Certified Action of the City of Raleigh Planning Commission

Case File / Name: S-28-13 / Waters Infill Subdivision

SUBJECT: S-28-13 / Waters Infill

Subdivision Layout

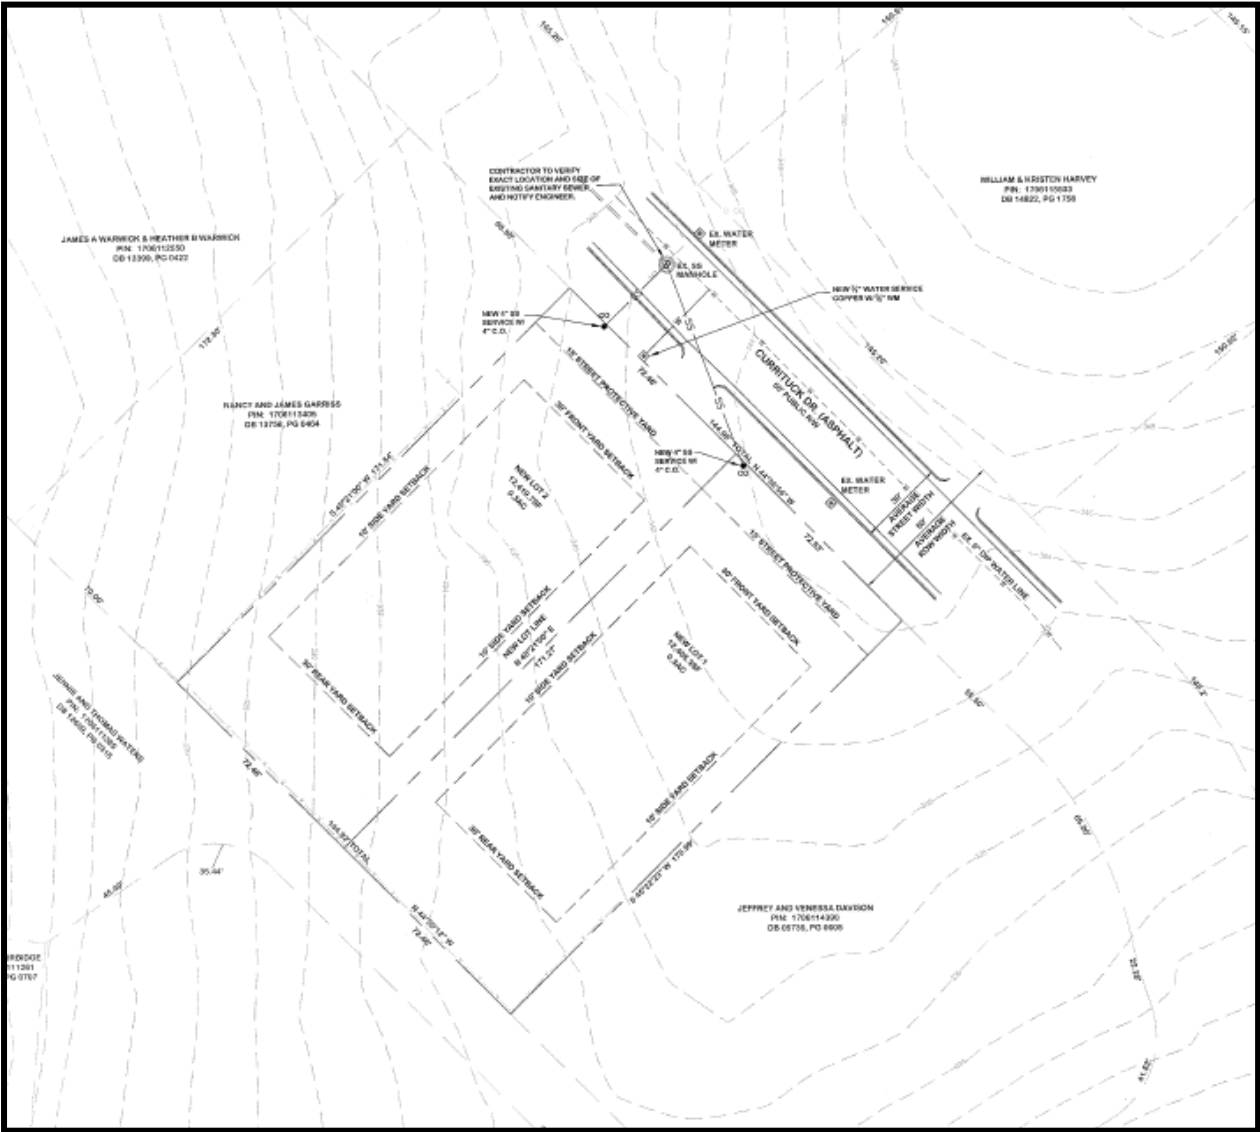
Lot 1 is proposed to be 0.28 acre. Lot 2 is proposed to be 0.29 acre.

Median lot size of surrounding lots .511 acres (80% = .409)

Proposed lot size lot #1 .28 acres (55% of median)

Proposed lot size lot #2 .29 acres (57% of median)

Median lot frontage of surrounding lots 144' (80% = 115')

Proposed lot frontage lot #1 72.53' (50% of median)

Proposed lot frontage lot #2 72.46' (50% of median)

Lot lines are angled from the street in a similar manner as typical surrounding lots. Lots consist of no more than 4 lines as is typical of surrounding lots. The building envelopes for the proposed new lots are placed in such a way that they are not one behind the other when viewed from the public street. Lots proposed may be adequately served by City services.

- (1) That an underground stormwater detention device will be installed and constructed on each lots such that there will be no net increase in stormwater runoff peak discharge rate leaving each lot between the pre and post development conditions for the 2, 10 and 25 year storms and 24 hour storm;

- (2) That the stormwater discharge from the detention device shall be converted to sheet flow before leaving the properties unless adjoining property owners agree to allow piping from the lots to the existing stormwater system located down stream;

- (3) That the impervious surface on each lot shall not exceed 4,000 square feet;
- (4) That the underground stormwater detention devices be constructed as open chamber devices to allow for water infiltration into the soil;
